PLANNING COMMISSION MEETING OF: FEBRUARY 22, 2007

**VAR-18210 - VARIANCE RELATED TO ZON-18208 - PUBLIC HEARING -
APPLICANT: FLETCHER JONES MANAGEMENT GROUP, INC. - OWNER:
FLETCHER JONES, SR. TRUST - Request for a Variance TO ALLOW 509 PARKING
SPACES WHERE 783 SPACES ARE REQUIRED on 9.34 acres at 400 South Decatur
Boulevard (APN 138-36-601-002), R-1 (Single Family Residential) Zone and C-2 (General
Commercial) Zone [PROPOSED: C-2 (General Commercial)], Ward-1 (Tarkanian).**

SDR-18206 - SITE DEVELOPMENT PLAN REVIEW RELATED TO ZON-18208 AND SUP-19129 - PUBLIC HEARING - APPLICANT: FLETCHER JONES MANAGEMENT GROUP, INC. - OWNER: FLETCHER JONES, SR. TRUST - Request for a Site Development Plan Review for a 123,669 SQUARE FOOT EXPANSION OF AN EXISTING AUTOMOBILE SERVICE FACILITY WITH WAIVERS OF THE PERIMETER LANDSCAPING REQUIREMENT TO ALLOW NO LANDSCAPING ALONG THE EAST PROPERTY LINE AND ALONG A PORTION OF THE SOUTH PROPERTY LINE WHERE AN EIGHT FOOT WIDE BUFFER IS REQUIRED; TO ALLOW A FIVE FOOT WIDE BUFFER ALONG A PORTION OF THE SOUTH PROPERTY LINE WHERE EIGHT FEET IS REQUIRED; TO ALLOW A SIX FOOT WIDE BUFFER ALONG THE WEST PROPERTY LINE WHERE EIGHT FEET IS REQUIRED; AND TO ALLOW A ONE FO

1 SERVICE SHOP FLOOR PLAN
SCALE: 1/4" = 1'-0"

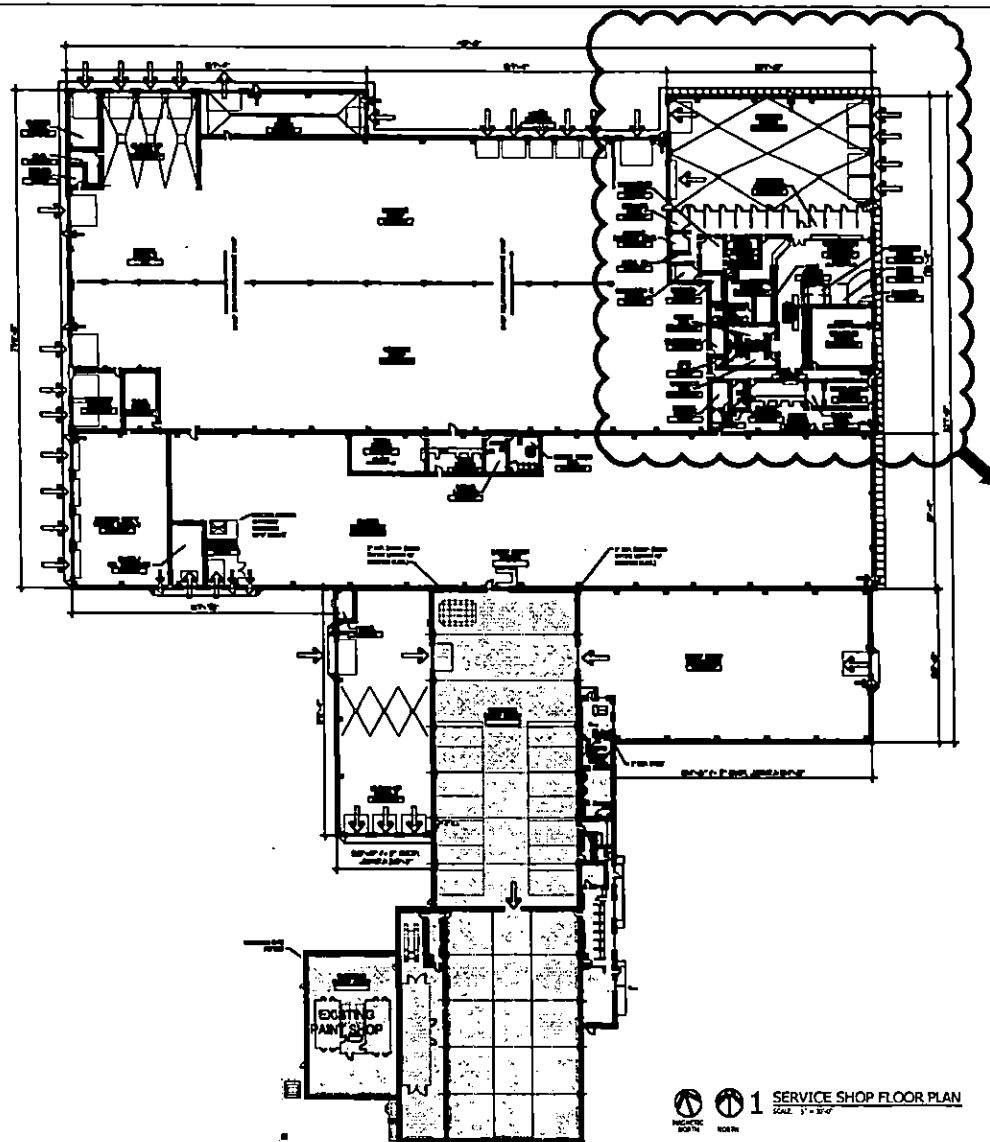
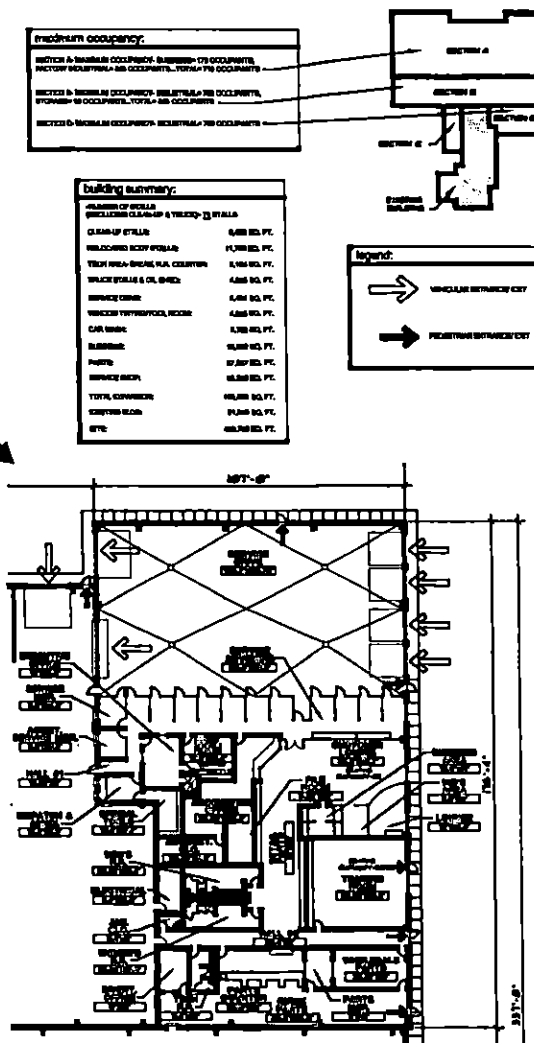
The site plan and elevations indicate service bays will be oriented to the north facing Meadows Lane as well as west towards a residential property line. In accordance with the Conditional Use requirements service bay access doors cannot face public ROW and such facilities shall be designed to minimize intrusion into adjoining properties. The Waiver request will allow service bays to face Meadows Lane. Staff recommends denial of the request as the project lacks landscape features to offset the visual effects of the bay doors.

Planning staff considers the proposed expansion as inappropriate for this area of the city. The project site is directly west of existing senior/retirement multi-family residential development to the west and within a one half mile radius of single family dwellings northwest along Meadows Lane. The project design does not meet the urban design standards of Title 19.08.050. The bulk and scale of the structure is more suitable within an industrial zoned area of the city. Furthermore, significant average daily vehicle trips will result with implementation of the project. Staff recommends denial of the request.

3. All development shall be in conformance with the site plan, landscape plan, and building elevations date stamped 11/17/06 except as amended by conditions herein.

5. A revised site plan shall be submitted to and approved by the Planning and Development Department prior to the time application is made for a building permit to reflect the changes herein: Screening shall be provided along all residential property lines in accordance with Title 19 Section 19.08.050.
